# SITE SAFETY PLAN FOR A 51 STORY NEW BUILDING AT 200 AMSTERDAM AVE NEW YORK, NY 10024

PROJECT: New Building At 51 Stories  
 200 AMSTERDAM AVE  
 New York, NY 10024, 642' HT  
 Block 1158, Lot 133, CB 107  
 Job # 122887224, BIN: 1030358

2D Site Safety Plans

PLAN VIEW AT CELLAR 2  
1/4"=1'-0"

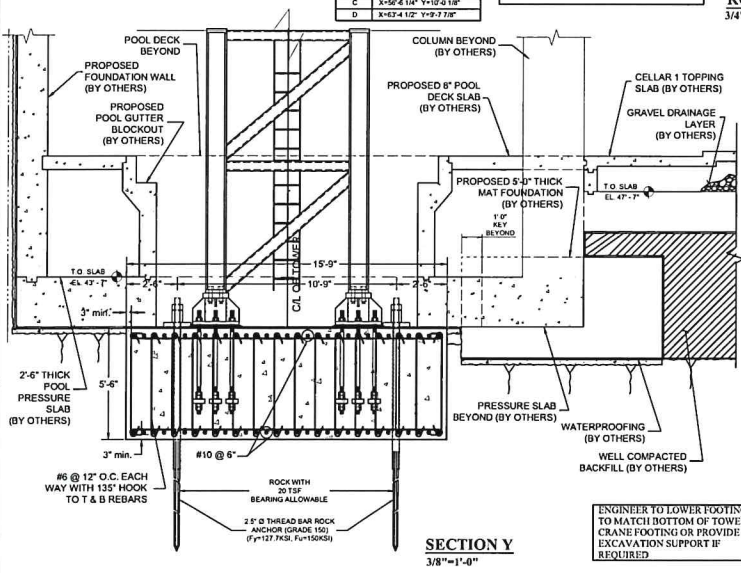
ROCK ANCHOR TO BE DETAILED AND VERIFIED BY GEOTECH. ENGINEER LICENSED IN NYS.

ROCK ANCHOR DETAIL  
3/4"=1'-0"

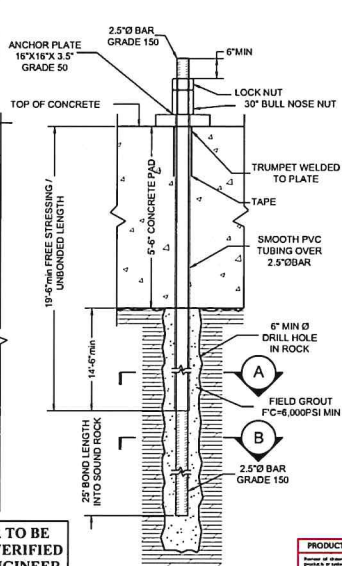
ENGINEER TO LOWER FOOTING TO MATCH BOTTOM OF TOWER CRANE FOOTING OR PROVIDE EXCAVATION SUPPORT IF REQUIRED.

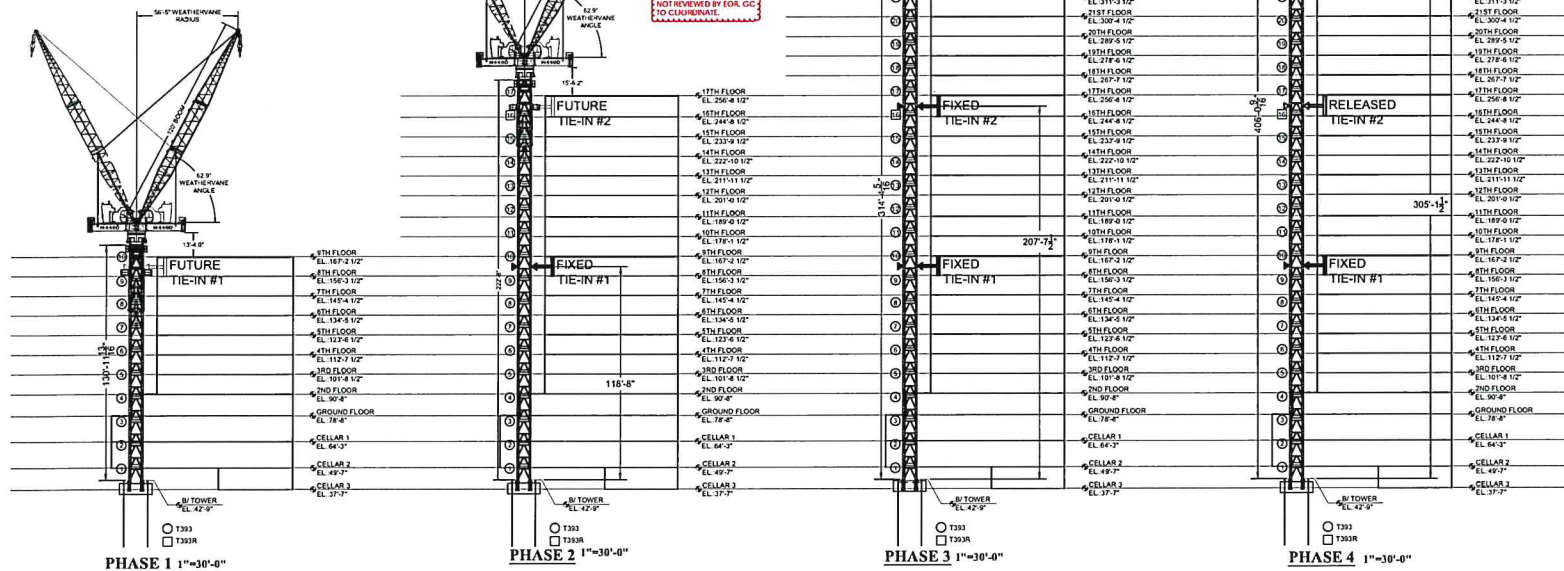
**DO NOT PHASING AND JUMP PLAN NOT REVIEWED BY EOR. DO NOT COORDINATE.**
